A Proposal of amendments to ECE Regulation No. 23

**UNIFORM PROVISIONS CONCERNING THE APPROVAL OF REVERSING LAMPS
AND FOR EXTERIOR COURTESY LAMPS FOR POWER-DRIVEN VEHICLES AND
THEIR TRAILERS**

Figure 4
Marking for an exterior courtesy lamps

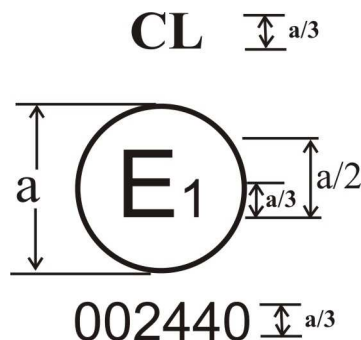
Insert a new figure 4 , to read:

The device bearing the approval mark shown above is a courtesy lamp approved in Germany (E 1) pursuant to Regulation No. 23 under approval number 2440. The approval number indicates that the approval was granted in accordance with the requirements of Regulation No. 23 in its original form or as amended by supplements 1 and/ or 2, as the case may be.

Figure 1

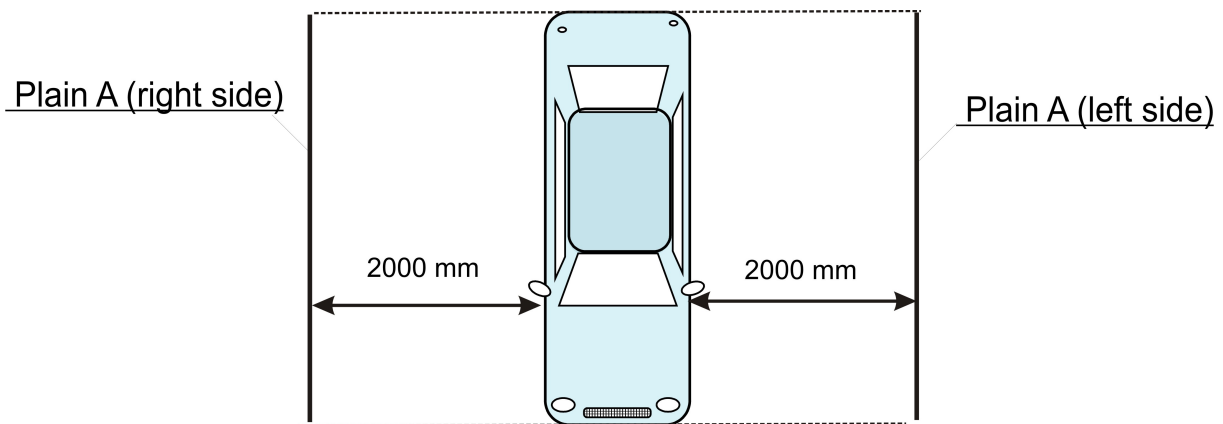
Initial idea was to describe the measuring procedure by a plain A as shown in figure 1 parallel to the longitudinal axis of the vehicle, which is located $2000\text{mm} \pm 10\text{mm}$ to the test set-up or to the left or the right side of the vehicle, measured from the extreme outer edges corresponding to the specifications specified in paragraph 2.14. of the Regulation No. 48 and which span in height above the ground from 250mm up to 2000mm and in length 2000mm to the left and 2000 mm to the right of the reference centre of the courtesy lamp or of each individual part of the courtesy lamp or corresponding to the length of the vehicle.

Figure 2

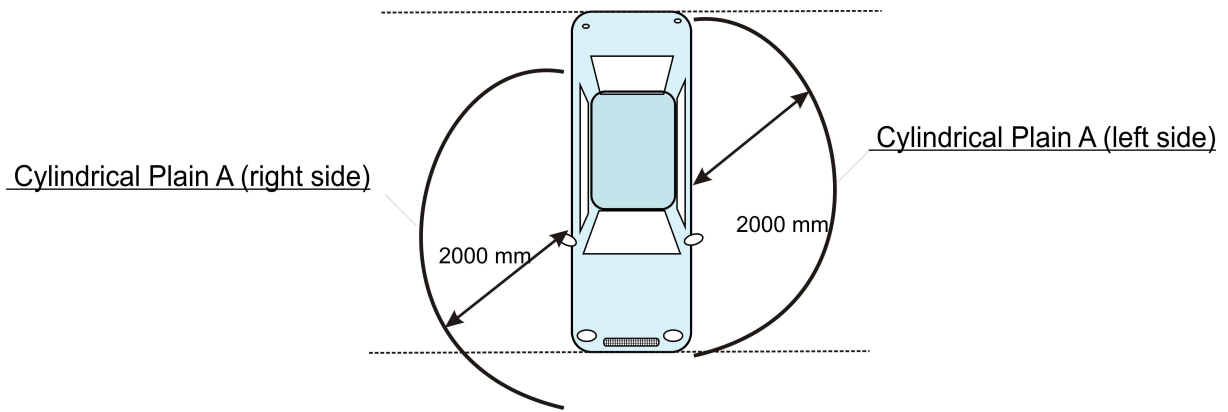
By the fact, that the following discussion results in procedure for a lamp approval, this procedure, proposed as an annex to the Regulation No. 48 was not more applicable. The Task Force decided to incorporate the test procedure into the Regulation No. 23 (Reversing Lamps). This requires at least a test procedure which is comparable to typical lamp measurements in a laboratory. Because these Requirements establish only maximum conditions to avoid undue dazzle etc. and also covering more or less the initial idea, the walls or better the plain A became a halve cylinder with the radius of 2m (see Figure 2).

The reference axis and the polar axis of this cylindrical “coordinate system” are the same.

Figure 3

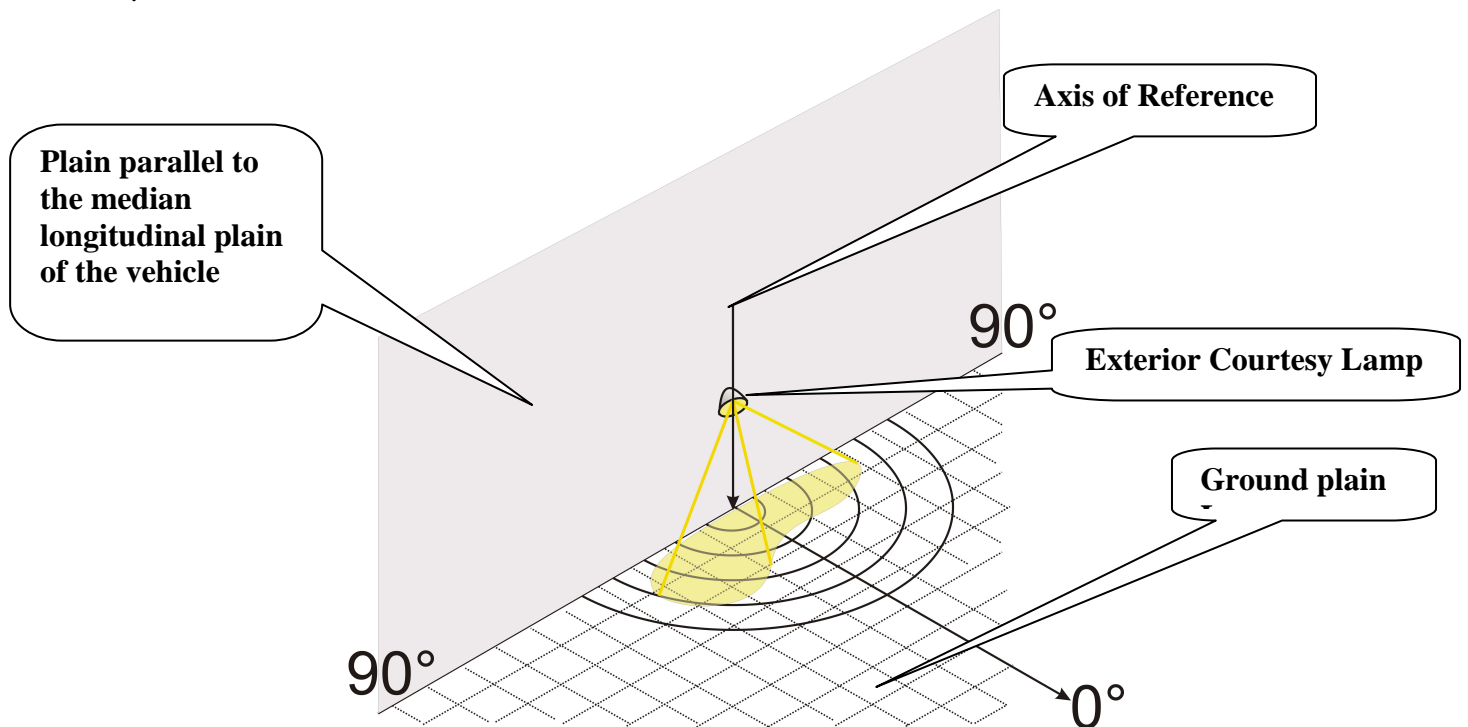
Figure 3 illustrates angular field as described by Table 1 in Paragraph 4 in Annex 3. This angular field represents the measurement of light in direction to the road

Figure 4

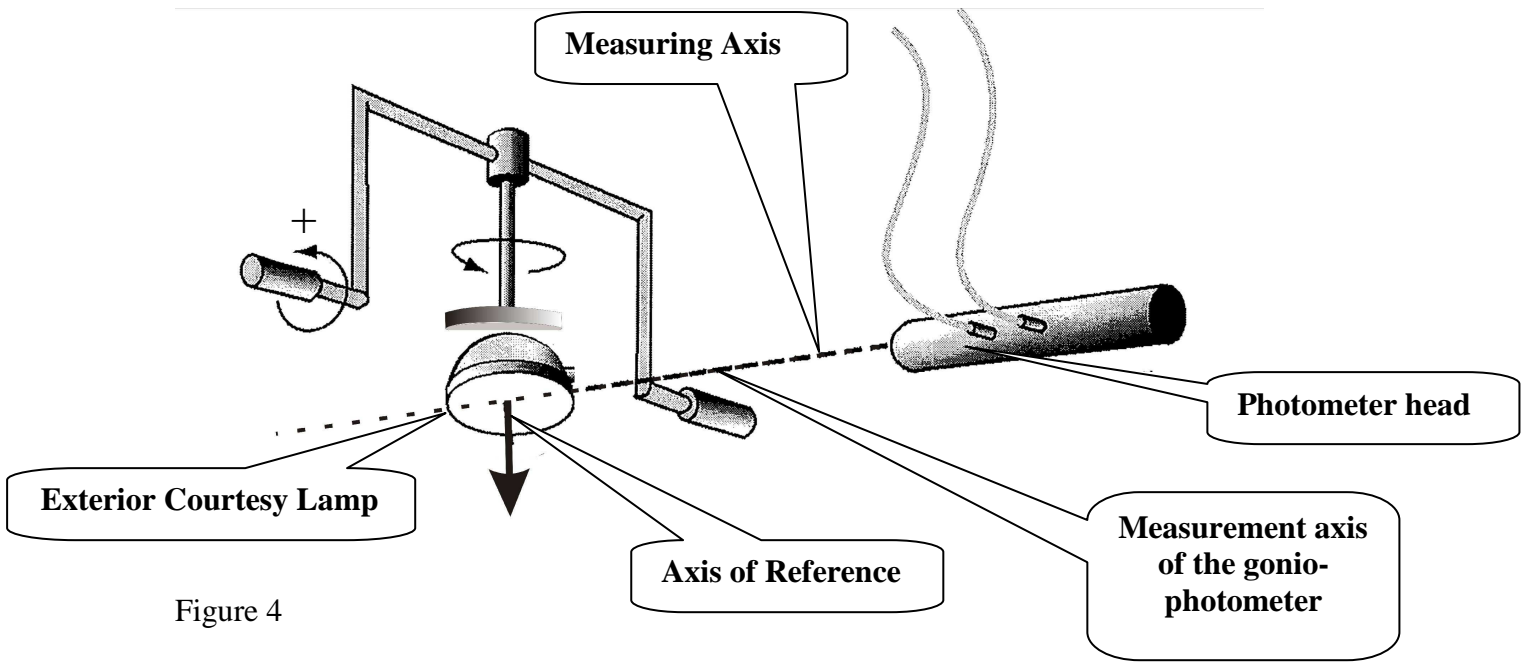
The corresponding set up of the exterior courtesy lamp on the goniophotometer with correct orientation of the axis of reference is shown in Figure 4:

Figure 5

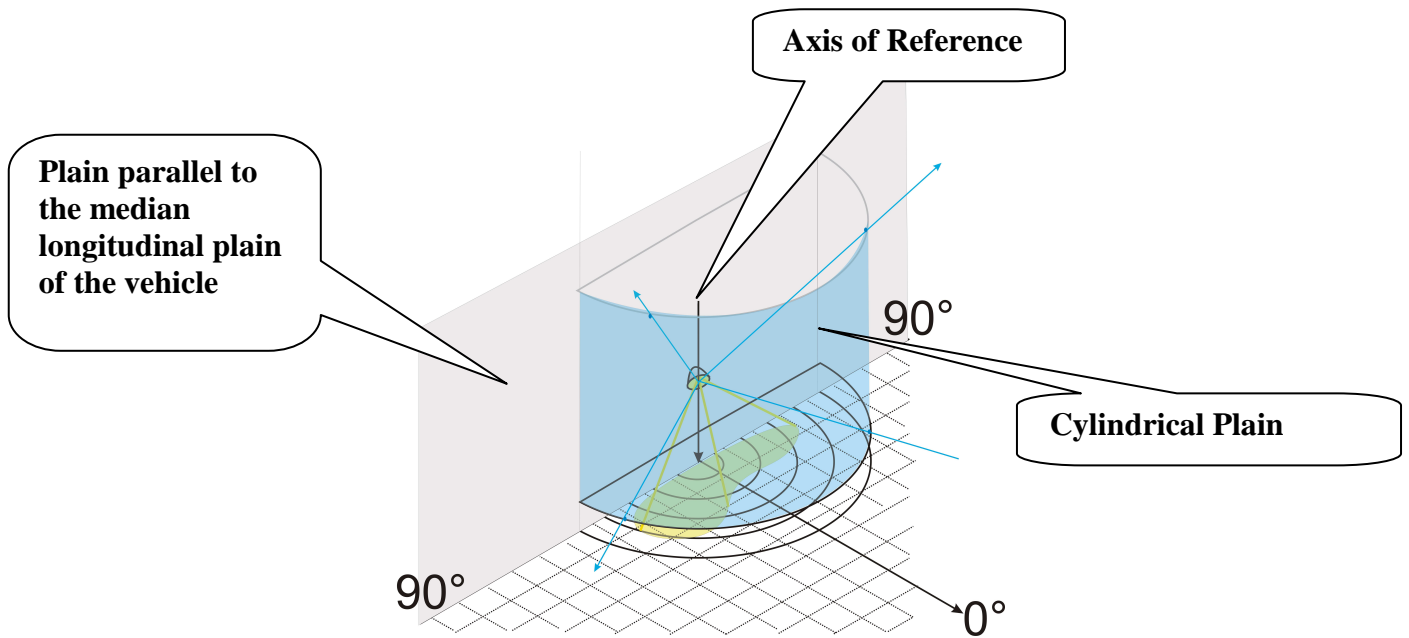
Figure 5 illustrates angular field as described by Table 2 in Paragraph 4 in Annex 3. This angular field represents the measurement of light in direction to other road users. Also it shows some of the rays cutting the lower or upper horizontal edges of this cylindrical plain.

Figure 6

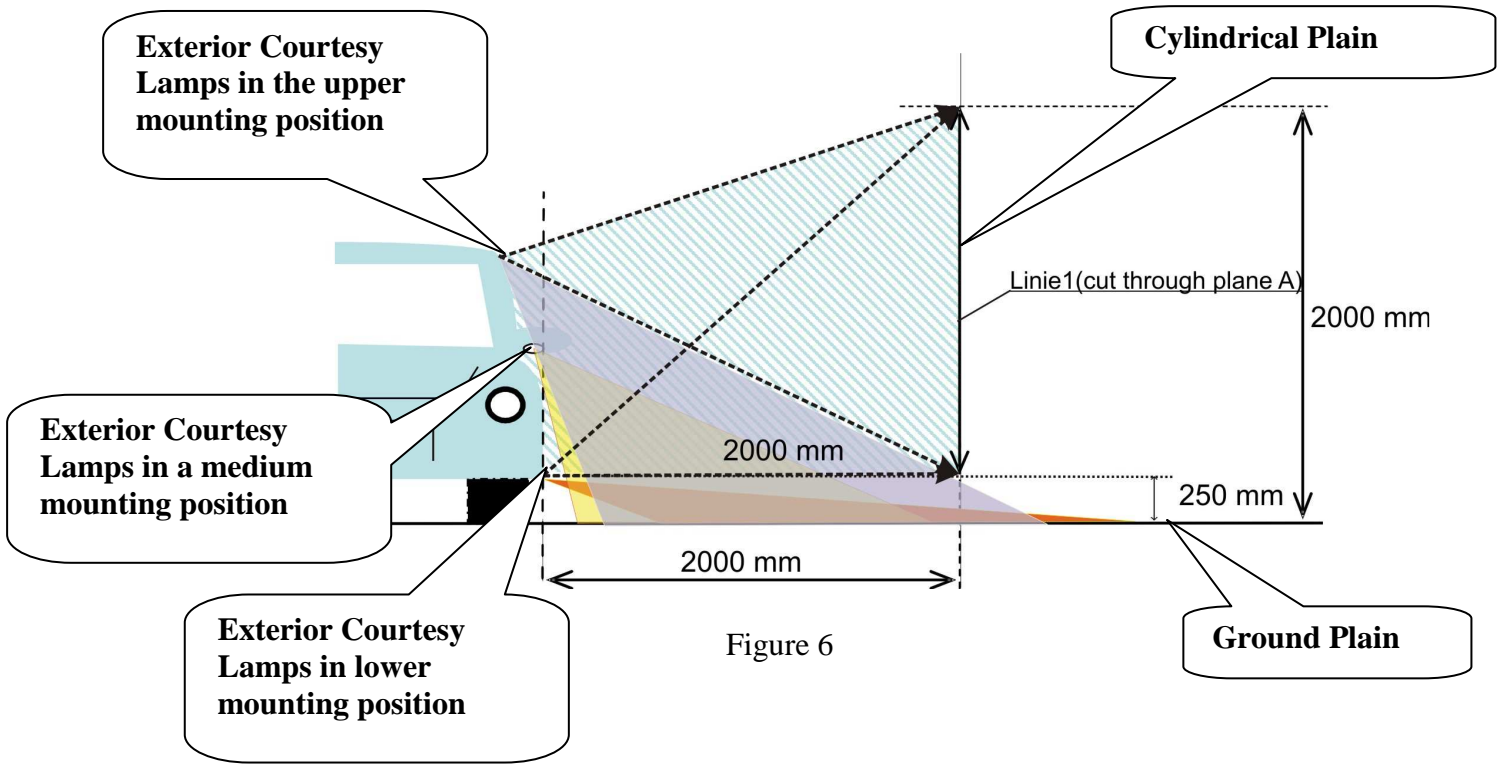
Figure 5 illustrates the vertical cut through the angular fields as described by Table 1 and Table 2 in Paragraph 4 in Annex 3. It shows also some of the dimensions and the variation of some angles depending from the mounting height of exterior courtesy lamps. Also you could

see again some of the rays cutting the lower or upper horizontal edges of this cylindrical plain.

Tolerance areas depending from the mounting height

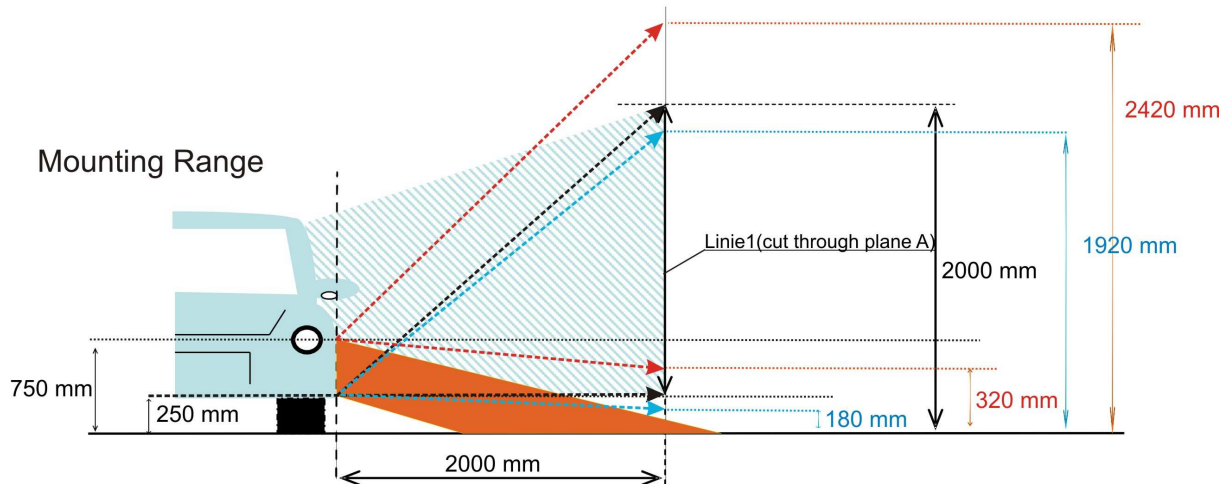
Tolerance areas depending from the mounting height shown for the lower and the upper position in the case of a mounting height range of 0.25m to 0.75m. Results are for the other mounting height ranges are equivalent.
